# UNITED STATES PATENT AND TRADEMARK OFFICE

APPLICATION NO.	FILING DATE	FIRST NAMED INVENTOR	ATTORNEY DOCKET NO.	CONFIRMATION NO.
10/053,143	01/17/2002	Thomas Deyette JR.	1001.1475101	4732

## Office Action Summary

***Claim Rejections - 35 USC § 102***

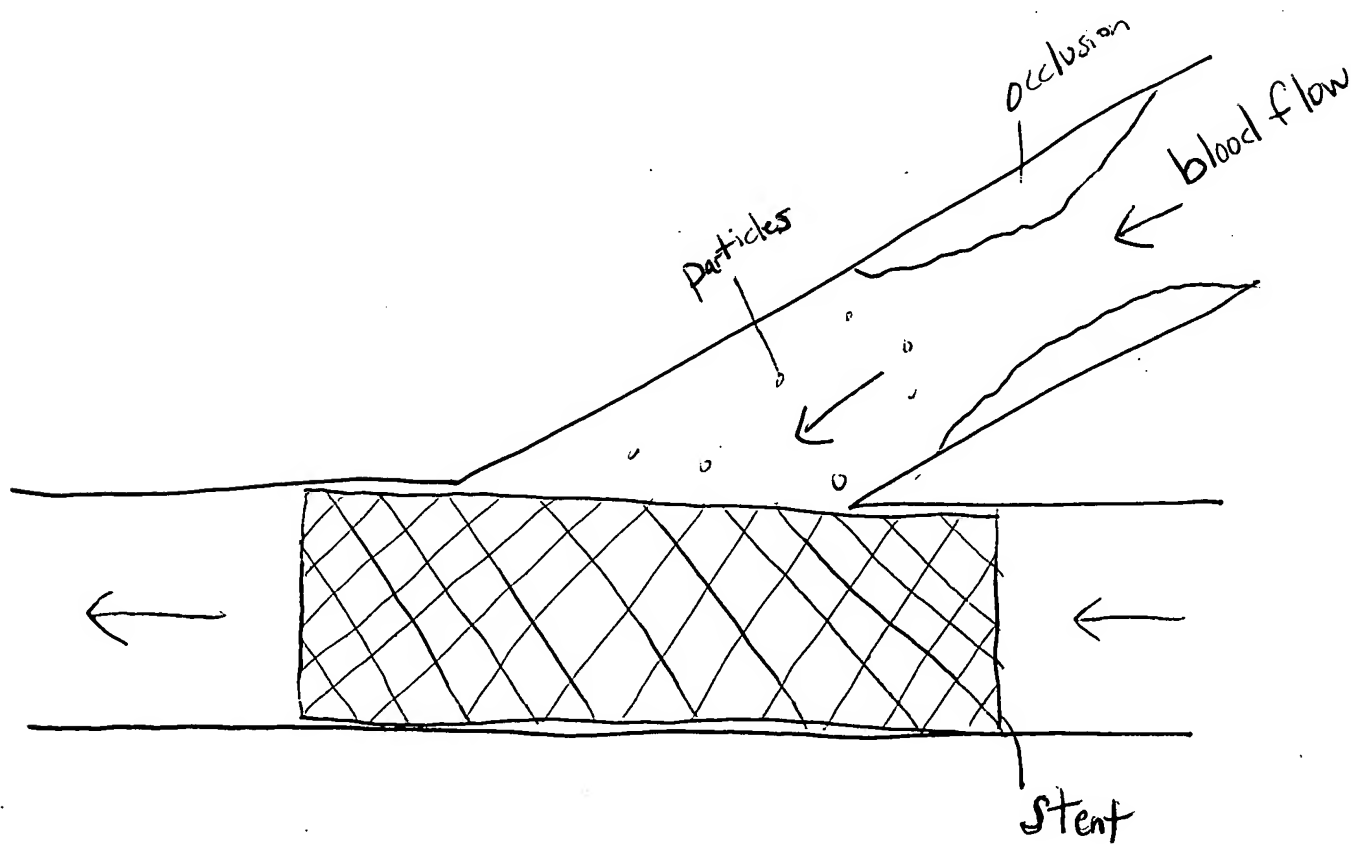
The examiner has identified the structures which are the claimed keys and notches. As for the stents/ stent/grafts not constituting a distal protection device, this argument is not persuasive for two reasons: 1. because the specification does not provide an actual definition of a distal protection device and a stent clearly protects the vessel wall from collapsing. And 2. if the stent were placed in a location distal to an occlusion at a location of a branching artery, the stent would be able to function as a

filter as blood attempting to pass through the stent would be filtered of particles in the blood which are larger than the pores of the stent. A diagram below would show the positioning of a stent whereby it would indeed filter out thrombotic material and therefore even meet applicant's definition of a distal protection device.
